September 27, 1973

Docket: 50-116

Subject: Malfunction of the UTR-10 Shim-safety Rod

FIGURE 1a

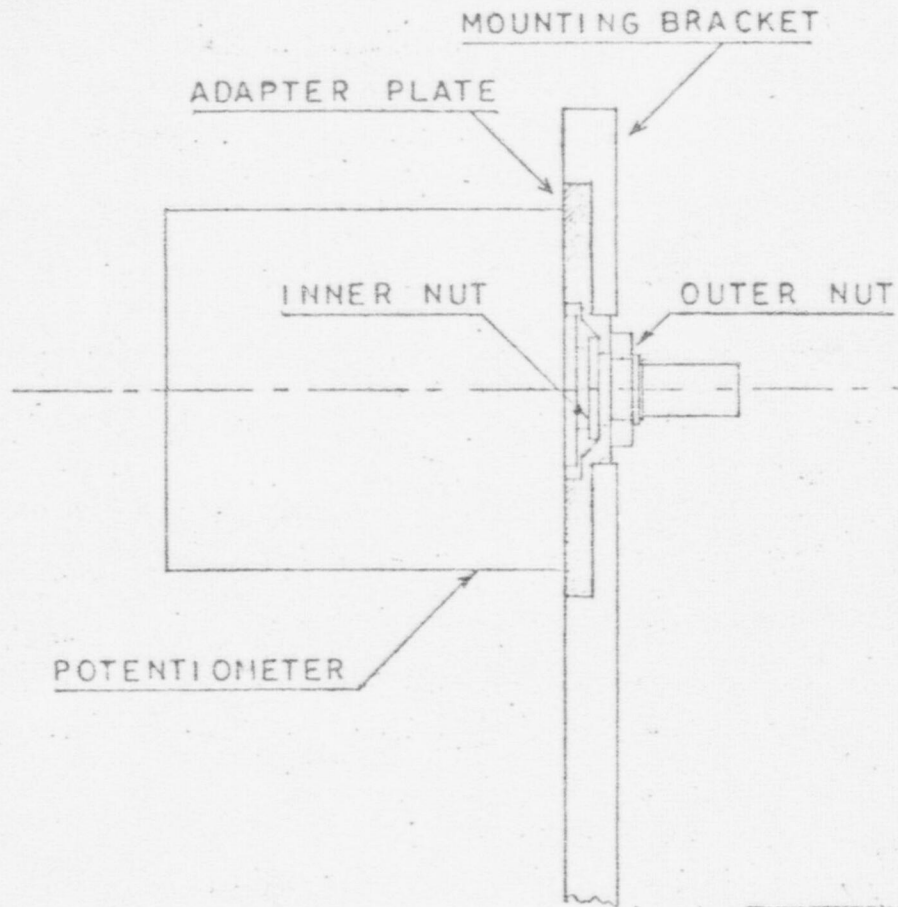
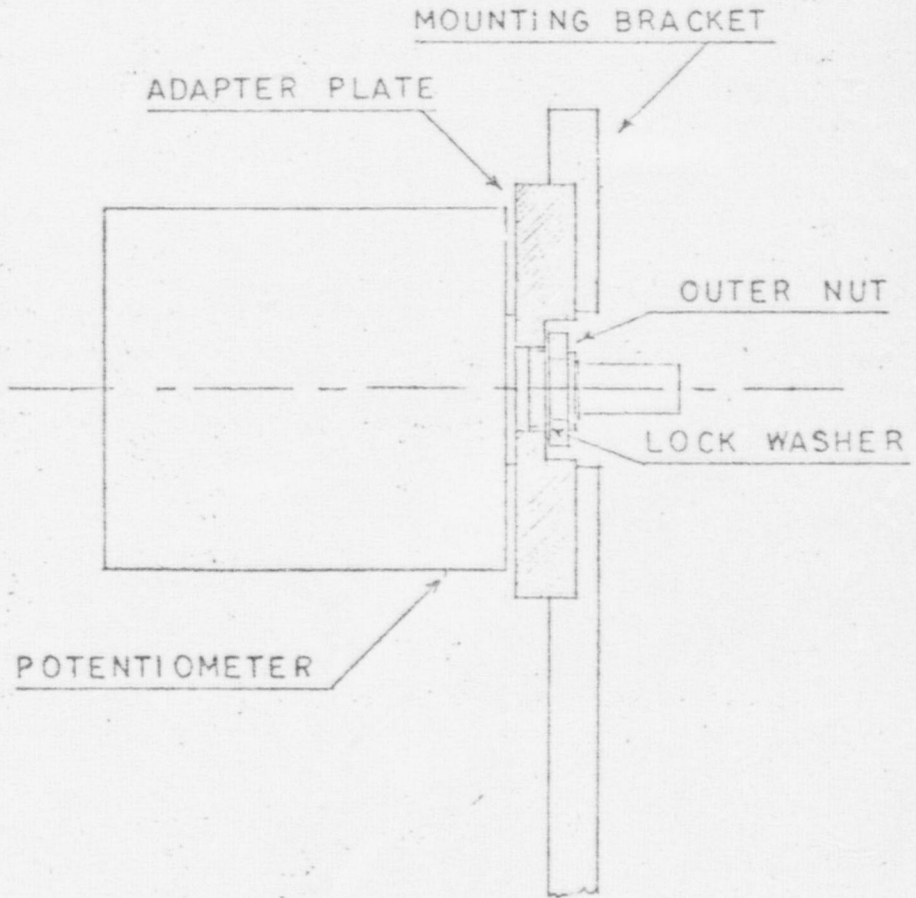
Inspection of the rod drive unit showed that the position potentiometer mounting nut was loose allowing the potentiometer gear to mismatch with the rod drive gear. The mismatch prevented normal spring-force insertion.

Two modifications were initiated. The potentiometer mounting hardware was changed to permit use of a lock washer. See Figures 1a and 1b. A fiducial mark was added to the nut and mounting bracket

to indicate during visual inspection if nut rotation has occurred. Second, the inspection interval has been reduced to six months.
